SOILS EVALUATION

Record Number: EHU-09-25-0917

Project Address: LEWIS RIVER RD, WOODLAND, WA 98674

Site Evaluation & Soil Report For Lot 3 @ Parcel Number: EM2405010

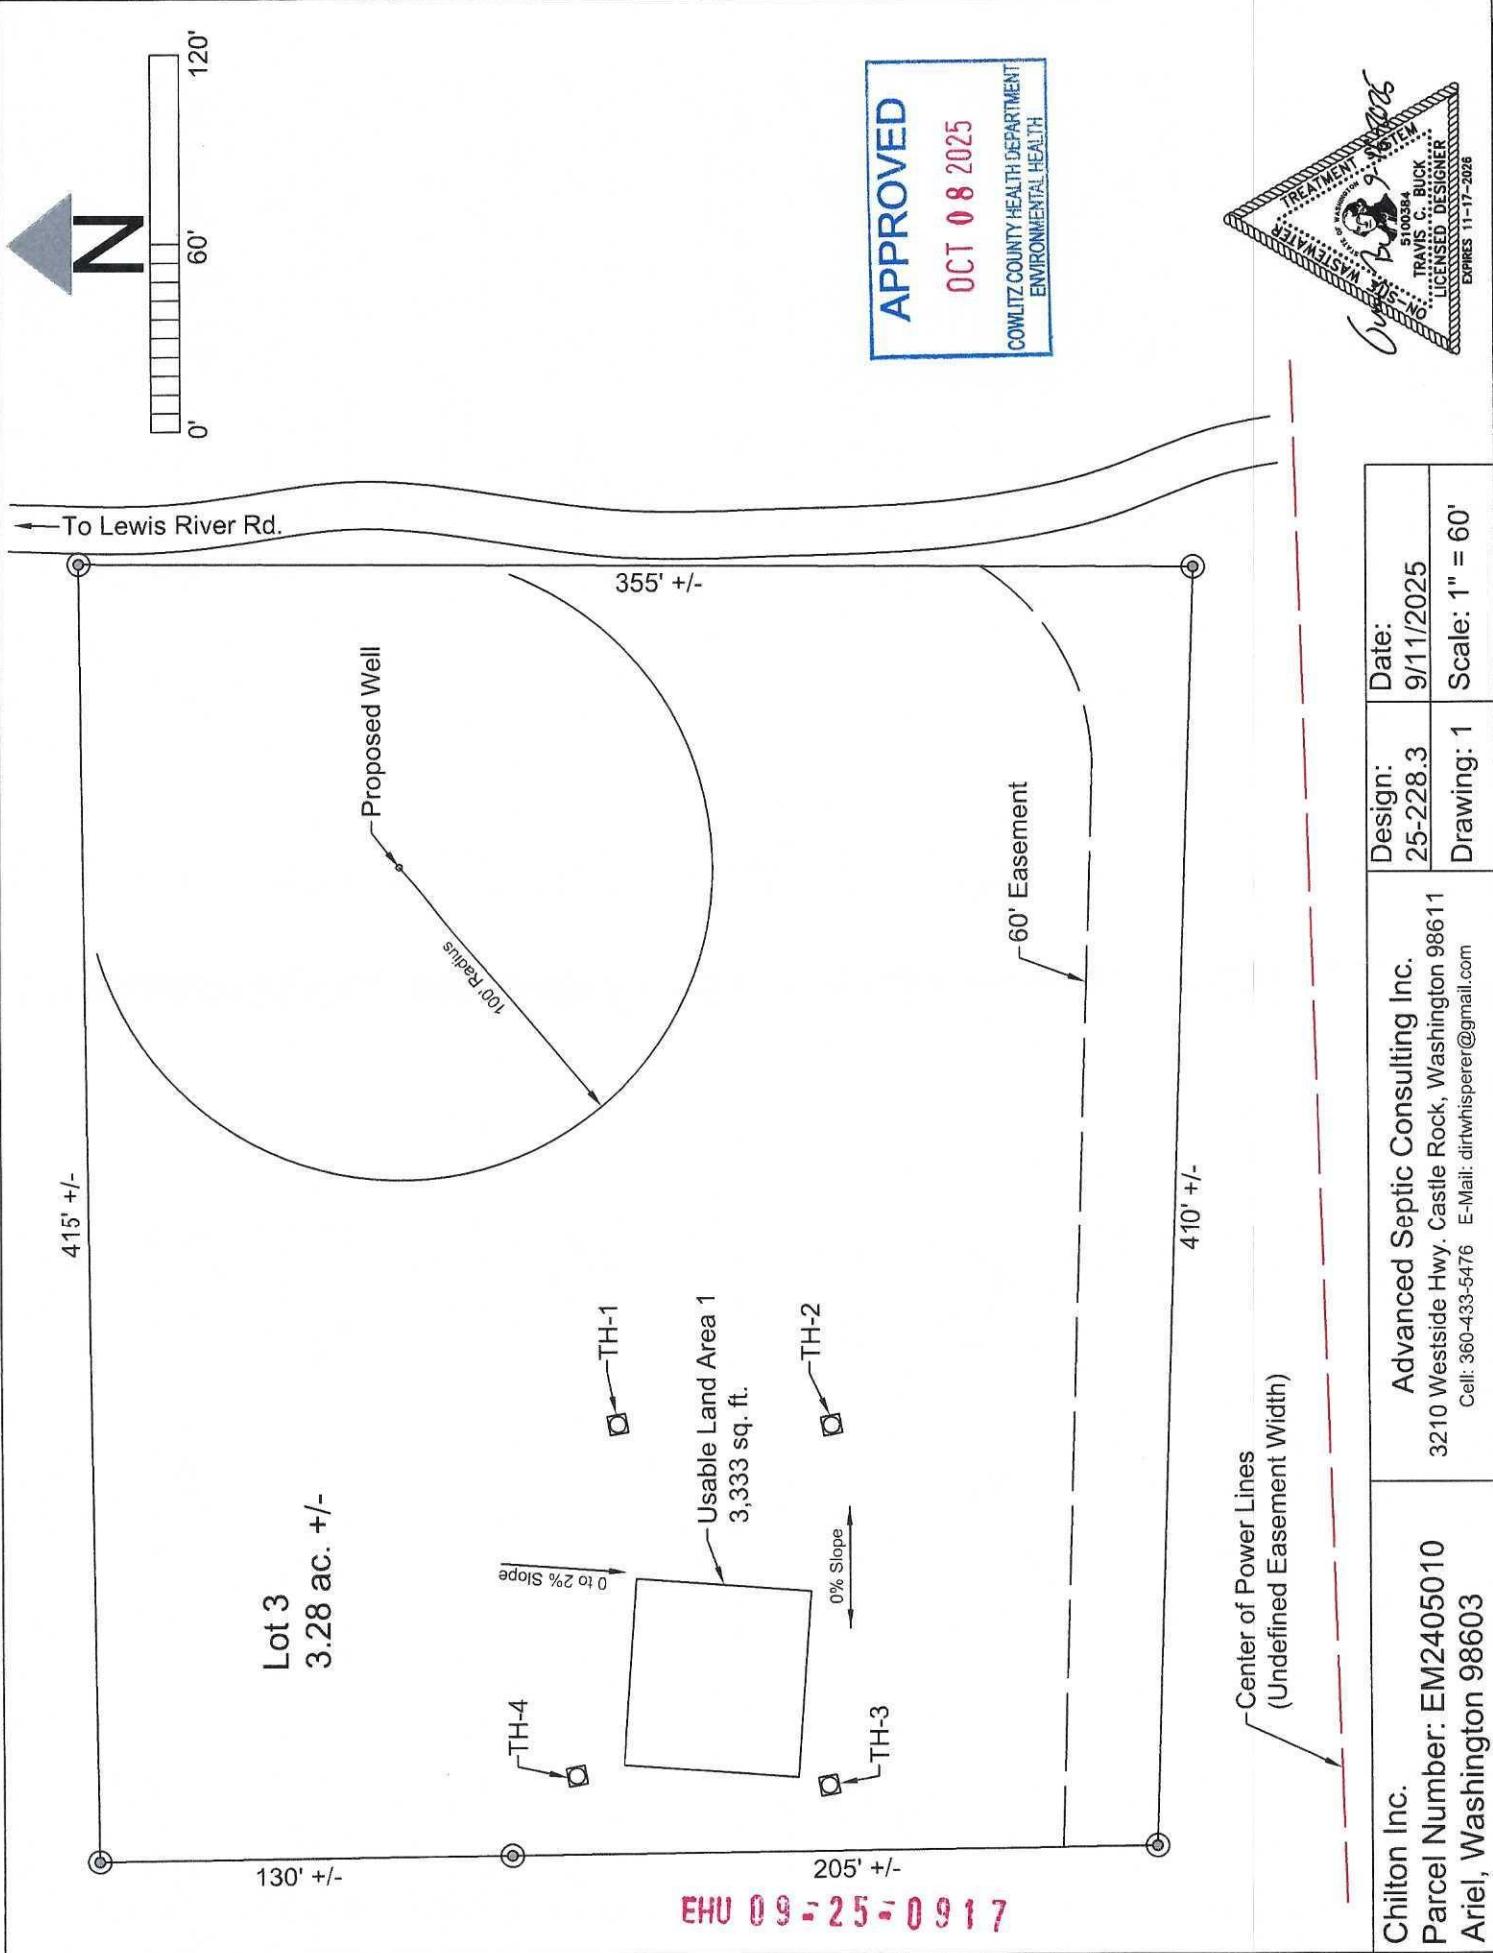
The EHU has evaluated the soil log(s), texture, structure, and compaction of the Soil and Site Evaluation Report submitted by a Washington State licensed Designer or Engineer.

This site appears to be able to, at this time, support an OSS as proposed.

Approved Soil and Site evaluations are valid for five (5) years from the approval date. The proposed septic primary and reserve area(s) set aside for future septic use must be protected from grading, fill, compaction, or any other alteration that may change soil characteristics. Soil and Site evaluations may be invalidated if the proposed septic area(s) are not protected.

For future well construction: When drilled, the well must maintain a 100' setback from the approved, proposed primary and reserve septic areas or new test holes will need to be opened and evaluated.
